STATE OF MAINE
DEPARTMENT OF TRANSPORTATION
16 STATE HOUSE STATION
AUGUSTA, MAINE
04333-0016

December 28, 2006
Subject: **Topsham**
Pin No. 14062.11
Amendment No. 2

Work under this contract is generally described as the construction of the MaineDOT TOPSHAM HIGHWAY MAINTENANCE GARAGE

DATE 08-19-06	SCALE AS SHOWN	JOB NO LP ENG 300-01-06	DRAWING NO A-1C
BY L. P. Pelletier	CHKD

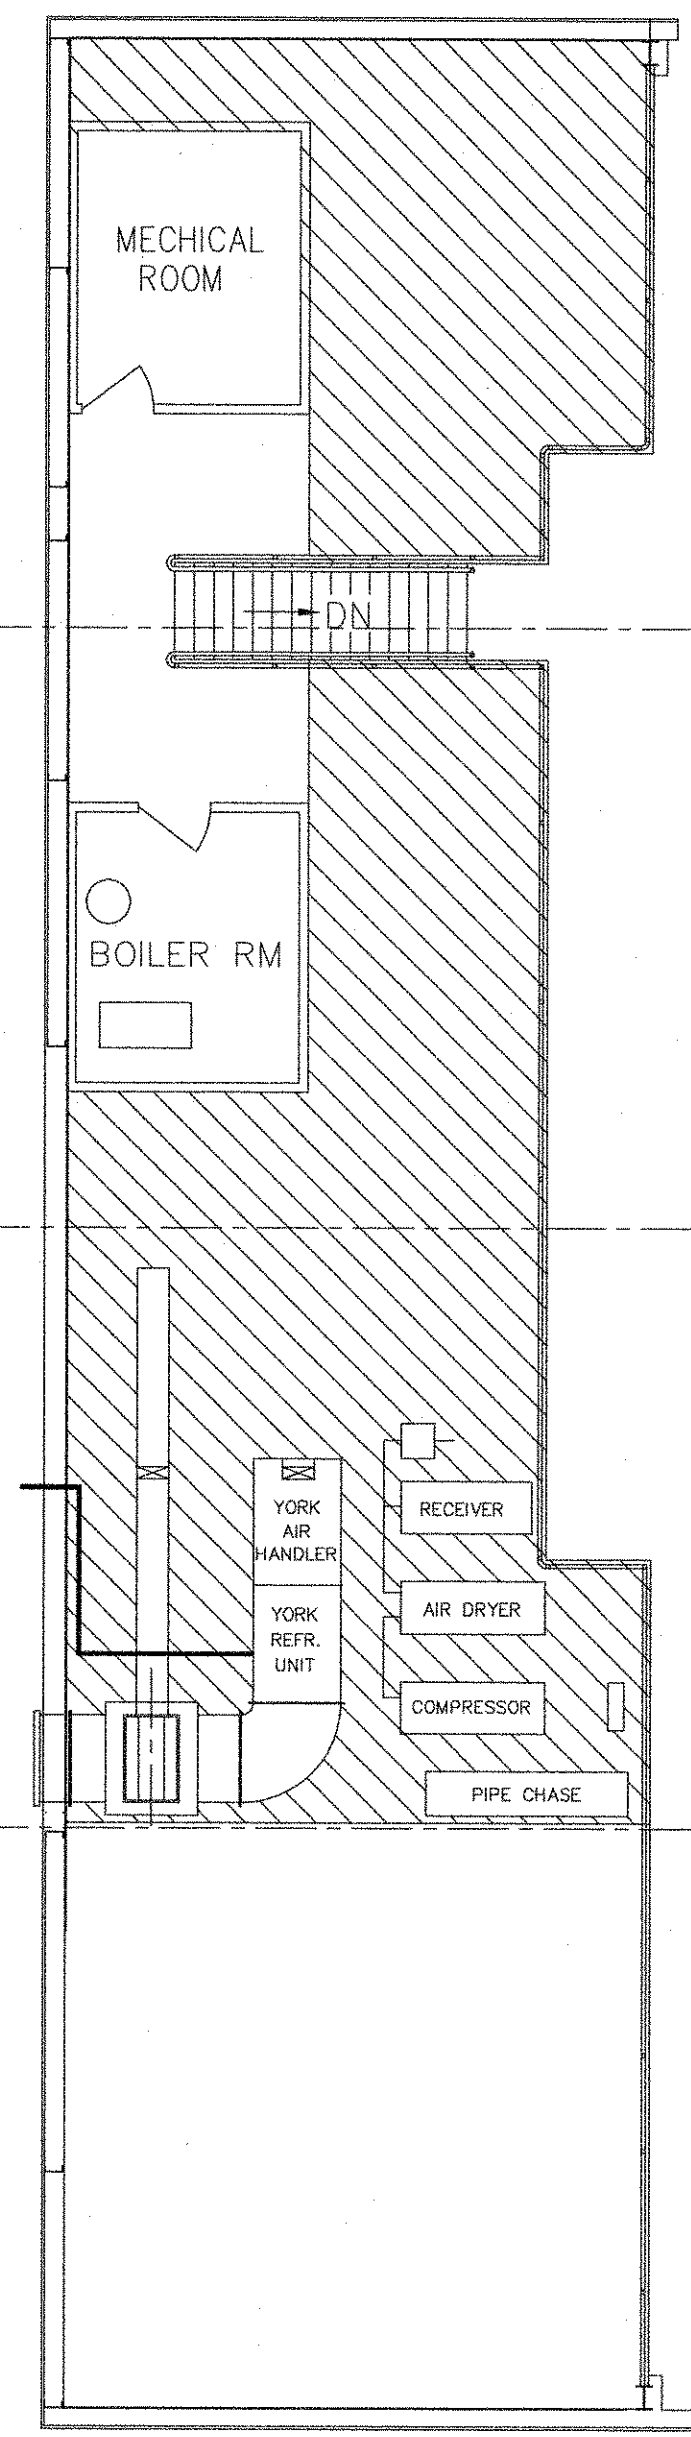
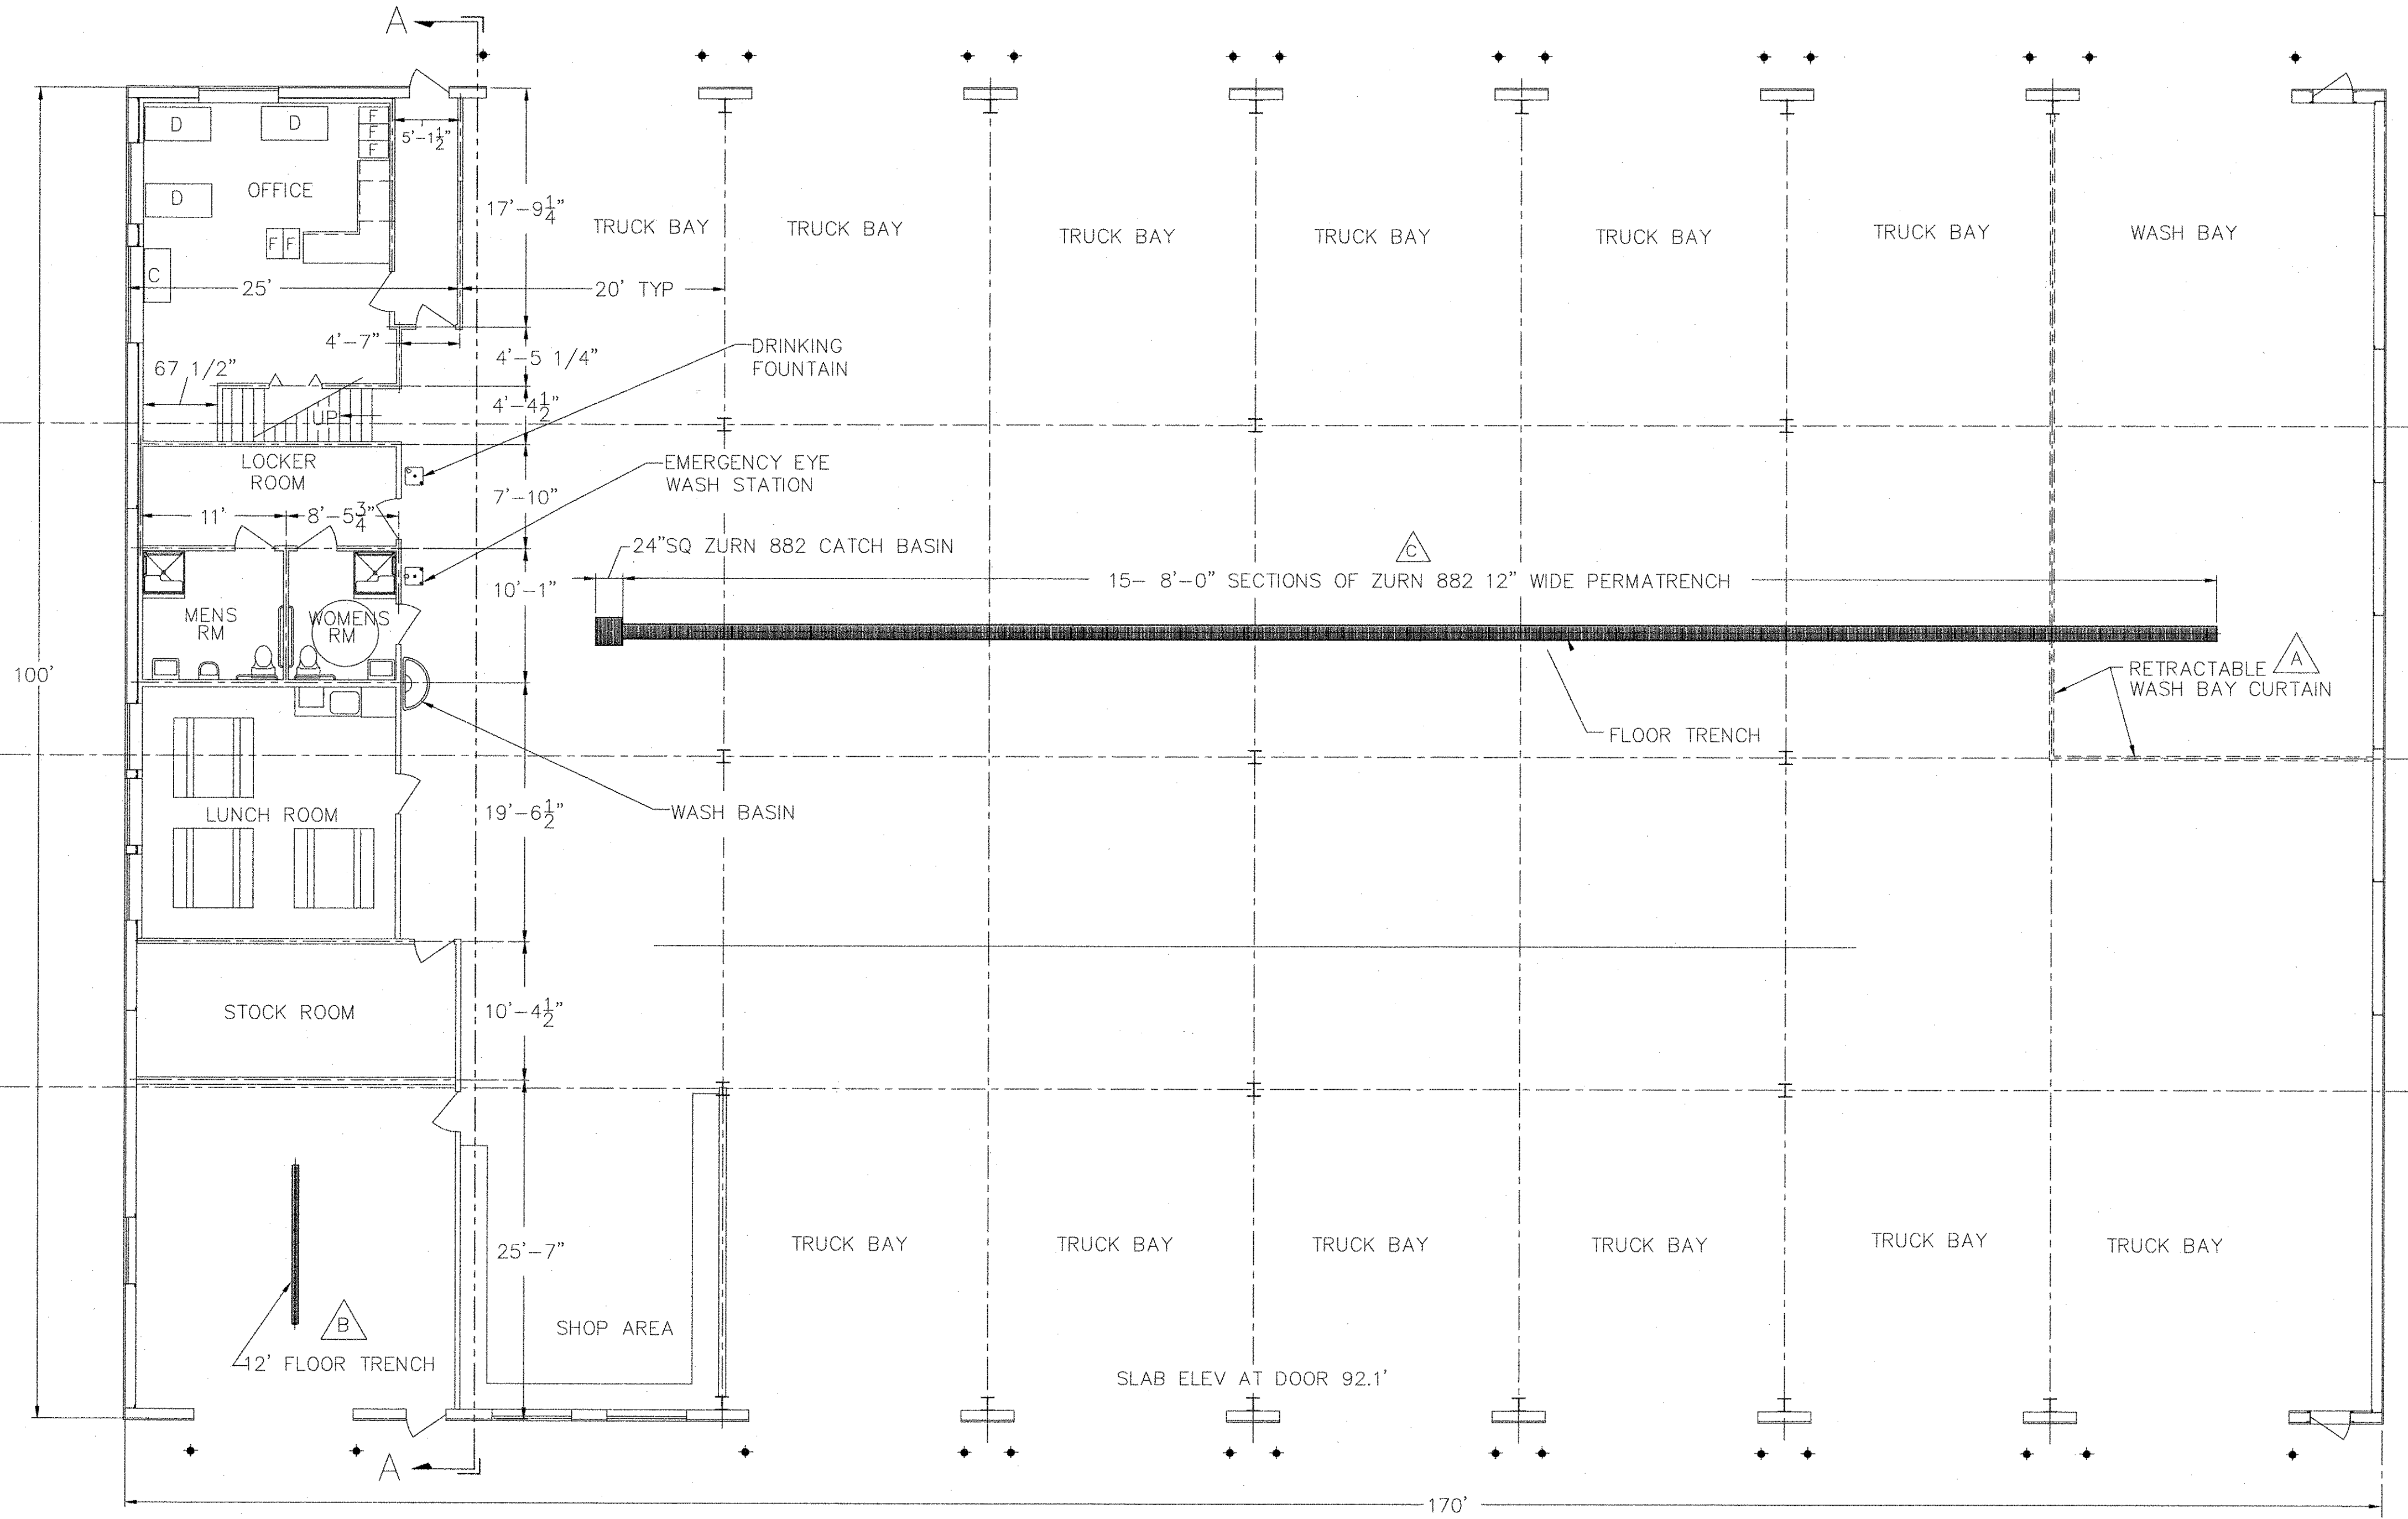
Question: Drawing A-1. There are no dimensions for layout of rooms.

Question: Is there supposed to be an emergency eye wash /shower for this project?

Response: Room dimensions have been added to updated A-1B plansheet

Response: An emergency eye wash station has been added to the attached updated Drawing A-1B.
